# MEDIC UPDATE

## TECHNICAL SERVICE BULLETIN

SUBJECT:		No: <b>TSB-07-13-010</b>	
<b>DTCs P0657, P1590, U0101, P0201 - P0206 &amp; POSSIBLE NO START</b>		DATE: <b>December, 2007</b>	
		MODEL: <b>See Below</b>	
CIRCULATE TO:	<input type="checkbox"/> GENERAL MANAGER	<input checked="" type="checkbox"/> PARTS MANAGER	<input checked="" type="checkbox"/> TECHNICIAN
<input checked="" type="checkbox"/> SERVICE ADVISOR	<input checked="" type="checkbox"/> SERVICE MANAGER	<input checked="" type="checkbox"/> WARRANTY PROCESSOR	<input type="checkbox"/> SALES MANAGER

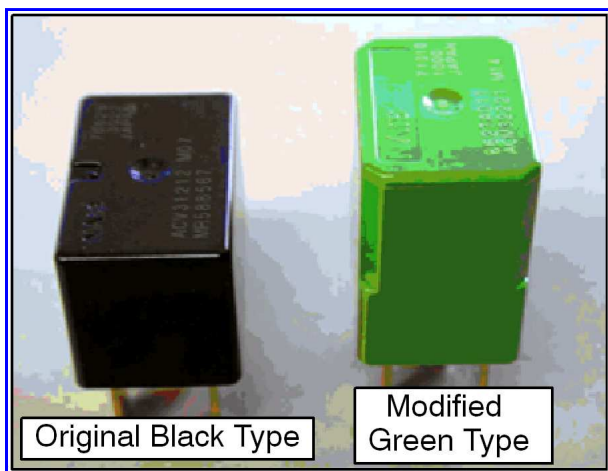
The customer may also complain of a no-start condition, however, dealers may find it difficult to recreate. The condition is caused by condensation freezing inside the relay, rendering it inoperative. Should you suspect very cold weather has caused either or both of these conditions in an affected vehicle, follow the procedures below and replace four (4) relays with a modified type.

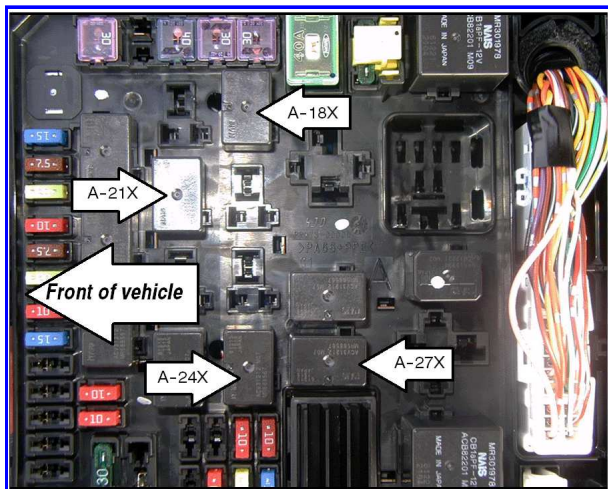
**NOTE: ONLY INSTALL A NEW RELAY IN LOCATIONS INDICATED IN THE PHOTO.**

6. Replace the following relays with the updated type from the Parts Information section of this bulletin.

- A-18X A/T Control Relay
- A-21X Throttle Valve Control Servo Relay
- A-24X Injector Relay
- A-27X Starter Relay
